Norlite Corporation

RE: Modifications to the Fugitive Dust Plan

In response to our meetings of October 6 and 12, 1995, Norlite is submitting revisions to the Fugitive Dust Plan prepared by Sci-Tech, Inc. on February 24, 1995 and last amended on September 5, 1995. The modifications are being made to enhance the plan, by incorporating dust collection systems at certain points with a high potential of fugitive dust emissions, based on relative emission rate estimates presented in Tables 3-1 and 5-2 of the Sci-Tech report. Specifically, dust collections systems will be added for the following additional points:

REVISIONS TO SCI-TECH, INC. REPORT

Figure 8-3

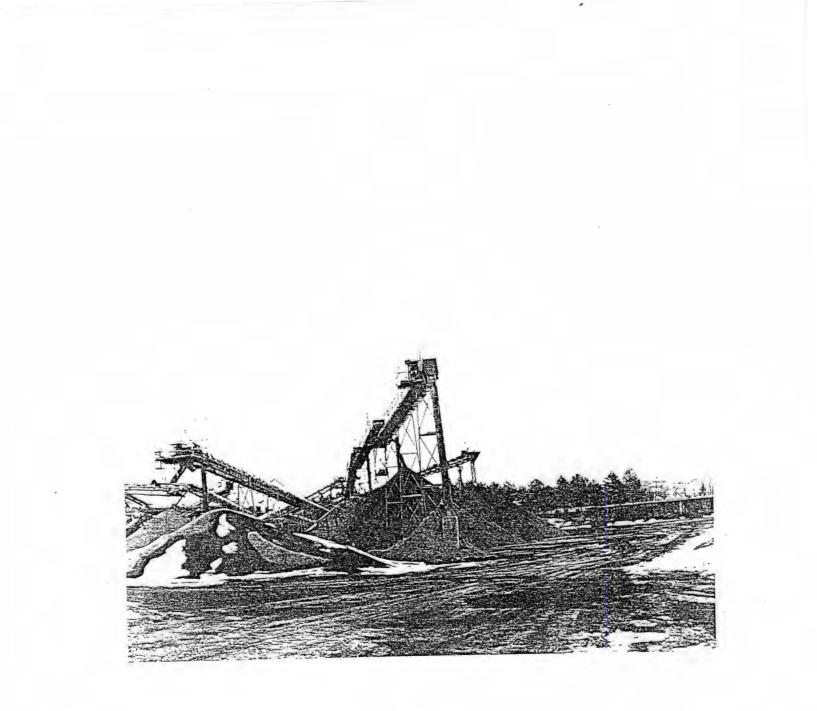
• <u>Finish Mill Block Mix Production</u>: Currently, block mix, a combination of bag house dust, light weight aggregate fines, and 3/8 inch light weight aggregate, is produced using two long conveyor belts and two 40 to 50 feet high drop chutes. Norlite will install a field conveyor (Fig. 8-2, Item 1) and a raising and lowering radial stacking conveyor (Fig. 8-2, Item 2) to eliminate the two high drop points (Fig. 8-2, Items 3 and 4, Figs 8-3 through 8-5) and shorten the distance the block mix must travel on conveyor belts. The current block mix conveyor belt (Fig. 8-2, Item 6; Fig 8-5) will be removed after the new stacking conveyor system is installed. The stacking conveyor will have a discharge chute located at the head pulley. Brightly colored bars or pipes will be attached to the chute and extend 12 to 18 inches beyond the end of the chute. The operator will control the height of the conveyor so that the end of the chute will not be more than 18 inches above the top of the pile, i. e., the colored pipe will always be in or on the pile. The maximum height of the pile will be approximately 34 feet.

The Finish Plant Area The new block mix field conveyor will be installed in the foreground of this photograph.

Figure 8-5

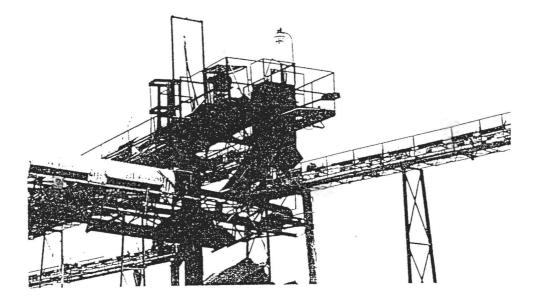
• <u>Stacking Tubes:</u> The stacking tubes for the block mix (Fig. 8-5) will be eliminated once the radial stacking conveyor has been installed. Outlets in the 3/4's stacking tube (Fig. 8-6) will be covered with rubber flaps to minimize dust emissions in this area.

The current block mix conveyor and stacking tubes will be removed after the radial stacking conveyor is installed. The stacking tube plugs frequently and causes excessive drop heights. The radial stacker will raise and lower to control the drop height of block mix.

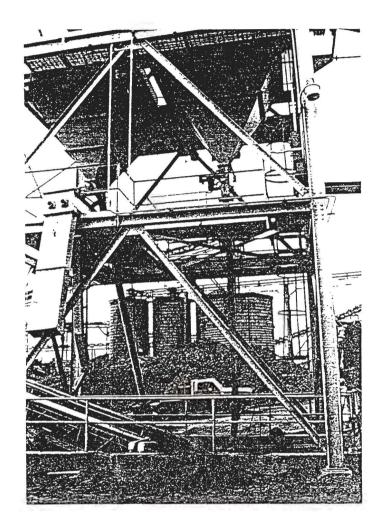
• <u>Clinker Dust to Clinker Belt</u>: The dust collected in the Barron system (Fig. 8-8) that is currently transferred to the clinker pile via the clinker conveyor belt will transferred to an enclosed hopper. The dust will be wetted in the hopper and transferred to the clinker pile as a wet mixture.

Excess air from the clinker cooler passes throught the Barron Fan system (shown). Dust is removed from the air and is transferred from the hopper on the upper right to the clinker belt via a square chute. Dust will be transferred to a hopper and later mixed into the product piles.

Figure 8-9 Primary Jaw Crusher and Ramp (foreground). Facing East.

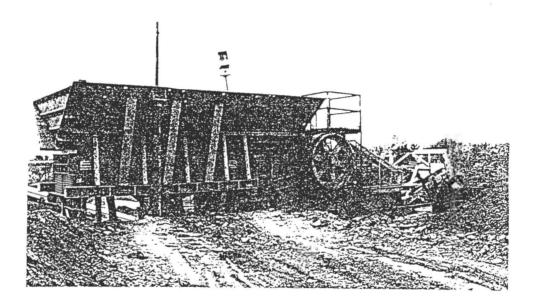
A partial enclosure or wind screen will be installed around the Jaw Crusher to contain dust emissions. A wet spray system will be installed to control dust while the loader is dumping shale into the crusher hopper. The use of electronic controls to activate and de-activate the spray headers will be investigated by Norlite. These additional controls will improve winter operations.

Shale (Shot Rock) is dumped into the portable jaw crusher hopper by a front end loader. Crushed shale exits the crusher on the conveyor at the right.

Figure 8-10 Secondary Crushing Operations

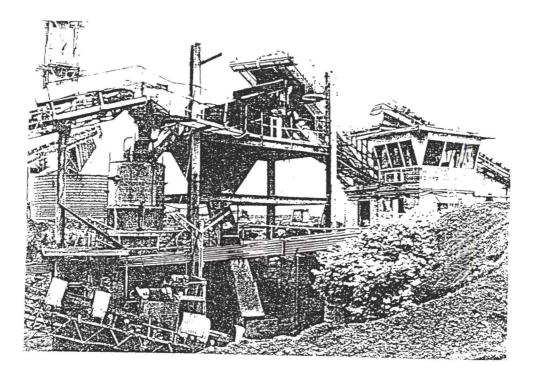
Covers will be installed over the Traylor Crusher, the 6x16 Screen, and the discharge points around the Traylor Crusher, and the partial enclosure around the 8x20 Screen building will be completed on all four sides to further contain dust.

Shale from the 12 C Crusher hopper is conveyed to the surge bin (far right) and then to the 6x16 screen (center). Oversize rock is crushed in the Traylor Crusher (left).

Figure 8-11 12 C Crusher Hopper Facing North-West.

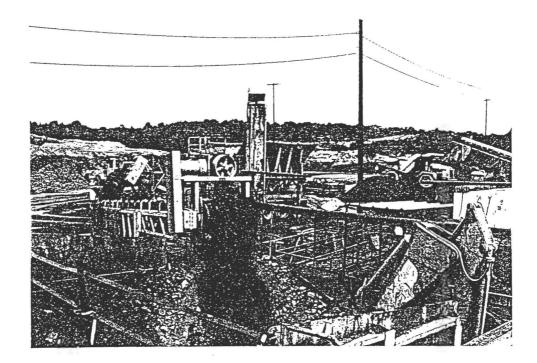
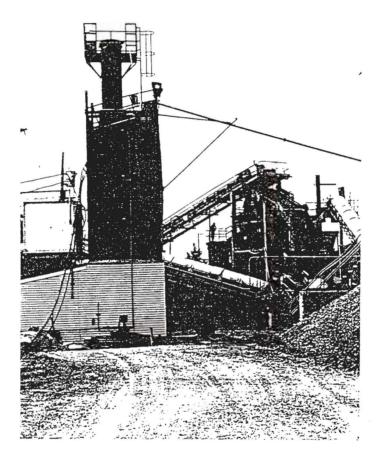
Stone is transferred to the 12 C hopper (Fig. 8-2, Item 16; Fig 8-11) from the primary jaw crusher via a conveyor belt. Dust will be suppressed in the 12 C hopper with two spray bars. One spray bar will be centered over the top of the hopper with the spray directed downward. The second spray bar will have two nozzles. One nozzle will be directed at the stone being discharged from the conveyor belt, while the second will point up at a 30° angle towards the center of the hopper.

Shale is conveyed to the 12 C Crusher Hopper from the primary jaw crusher via a transfer conveyor. One spray bar will be installed over the center of the hopper to suppress dust. Another spray bar will be installed closer to the head pulley of the transfer conveyor.

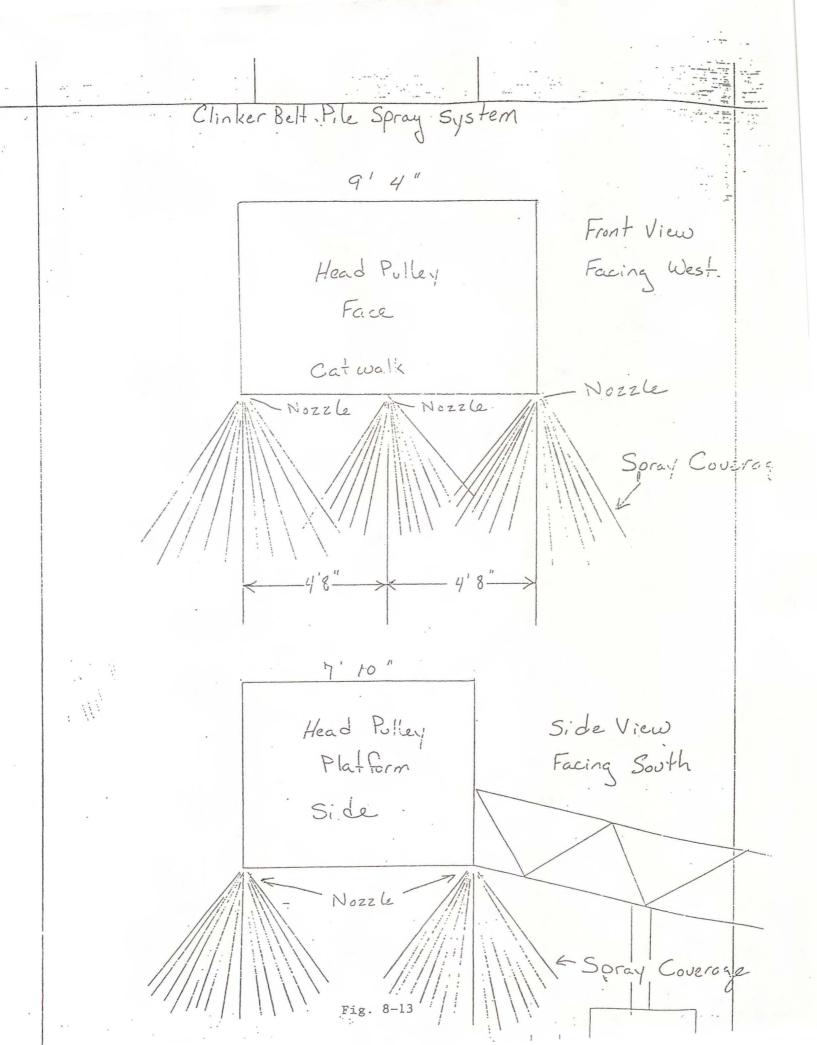
• <u>Improved Baghouse on Soda Ash Silo:</u> The original Soda Ash Silo baghouse (Fig. 8-2, Item 14) was removed and replaced with a modern pulse-jet bag house bin vent (Fig. 8-12) in June, 1995

The Soda Ash Silo bin vent was replaced with a much larger Aeropulse bin vent (shown).

Fig. 8-16

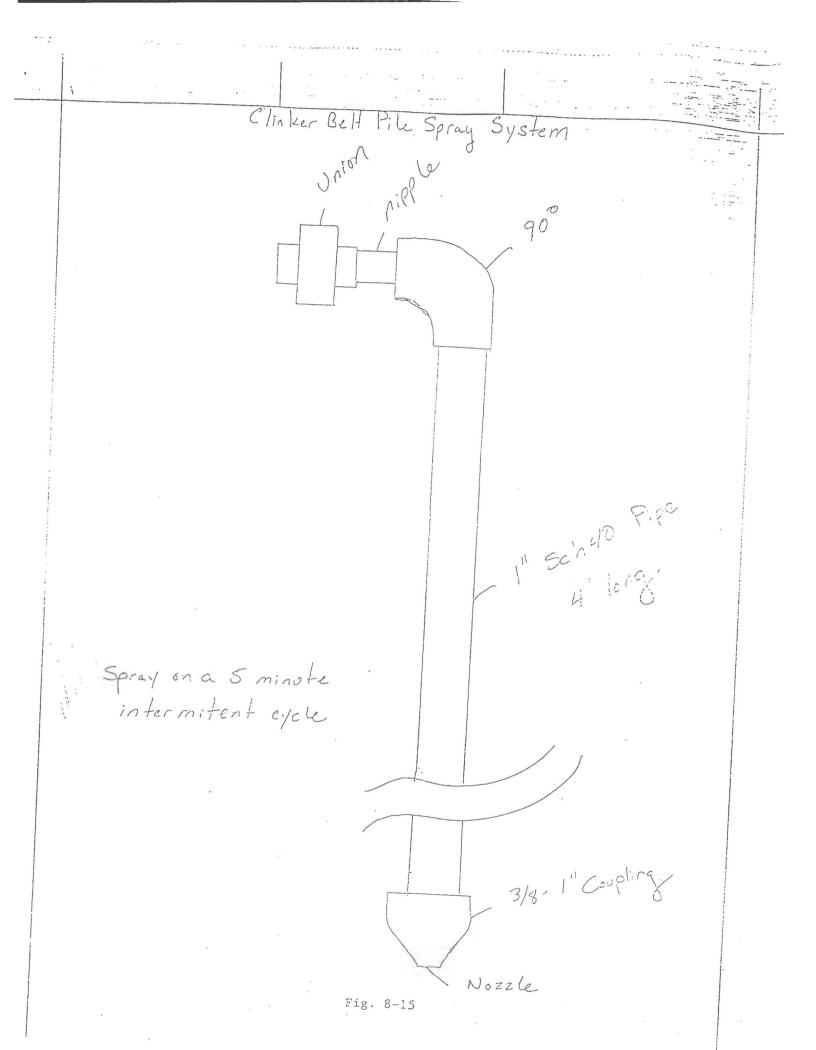
• <u>Kiln Clinker Conveyors</u>: The wet dust suppression systems for the clinker belts have been designed by Norlite. These systems have been designed to spray water at a mass flow rate of 1.5% of the aggregate mass flow using a hollow cone spray nozzle similar to figure 8-25. Current literature shows that 0.5 to 1.5:100 (0.5% to 1.5%) water to product ratio by weight is sufficient to make the material wet and suppress dust. This is equivalent to about 1 gallon per ton of stone. Each clinker belt (Fig. 8-2, Item 11) will have two spray systems. One system operates on a 5 minute intermittent cycle to suppress dust on the clinker pile. The second spray bar operates continuously to wet the clinker as it falls off of the head pulley. The pile spray system is detailed in figures 8-13 through 8-15. The head pulley discharge spray bar has one nozzle and will be similar to figure 8-16.

Clinker Belt Pile Spray System ⇒A (______ nipple union $\rightarrow A$ Tre 1) Misr 1" sch 9:02 4' long View A.F. 3/8-1" Coupling Nozzle Spray on a Smirute intermitent cycle Fig. 8-14

Conveyor Discharge Sprays 1 Spray Nozzle Locations: 12 C - 1 Belt (To Surge Hopper) 126-2 Ert- (Tr. 6x16 Screen) Clinker Conveyer Head Fulley Traylor Crusher Dischauge 2 Nozzles Directedat Discharge under Traylor Crusher

Figure 8-17 Finish Plant Fines Silo and Fines Chute

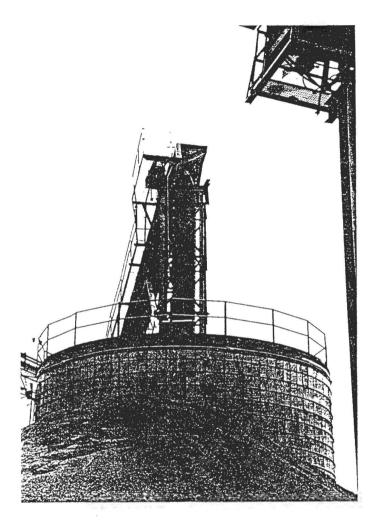
A second source of fugitive dust was a defective drop chute on top of the silo (Fig. 8-2, Item 10). The chute had several wear holes caused by abrasive scouring. During May, 1995, the chute was repaired by replacing eroded material with an abrasion resistant metal. The repaired areas were fabricated as bolted sections which can be readily replaced for easier maintenance (Fig. 8-17). Regular inspection will ensure that the chute is properly maintained.

The West face of the fines silo chute (shown) has been redesigned with easily changed, wear resistant plates (also shown).

Figure 8-18 Shipping Tunnel Mouth Enclosure

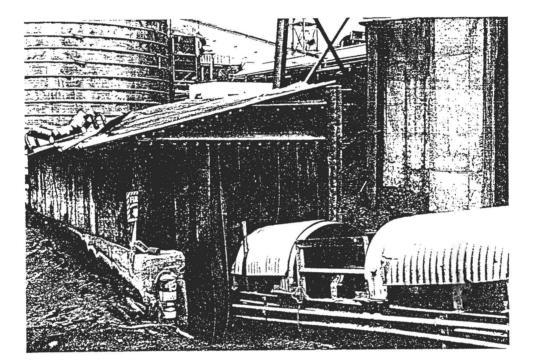
• <u>Shipping Tunnel Mouth:</u> The mouth of the shipping tunnel under the dust and fines silos was covered with a curtain of conveyor belt strips (Fig. 8-18) to prevent dust from escaping the area shown as figure 8-2, Item 9. Under normal operations dust is not produced in this area. During block mix production the level in the bag house dust silos decreases. Some dust is produced when the silo reaches its near empty point. At this point the finish mill operator will stop block mix production or switch to the other dust silo.

Norlite will also seal the joints and seams of the shipping tunnel entrance shelter and connect this area to the negative pressure baghouse filter system to collect dust in this area.

The Shipping conveyor belt (right) extends under the three silos (left, not shown). The enclosure covering the mouth of the tunnel will be improved and sealed.

Figure 8-19 Rear Kiln Seals

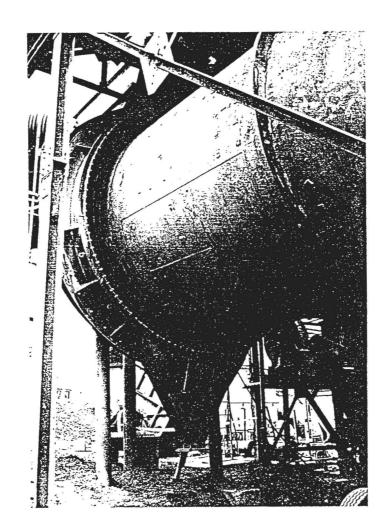
• <u>Kiln Seals</u>: The seals at the rear of each kiln (Fig. 8-2, Item 13) will be maintained during planned kiln shutdowns as needed to prevent emissions from this area (Fig. 8-19).

The seal mechanism and knock out box will be maintained during all planned shutdowns.
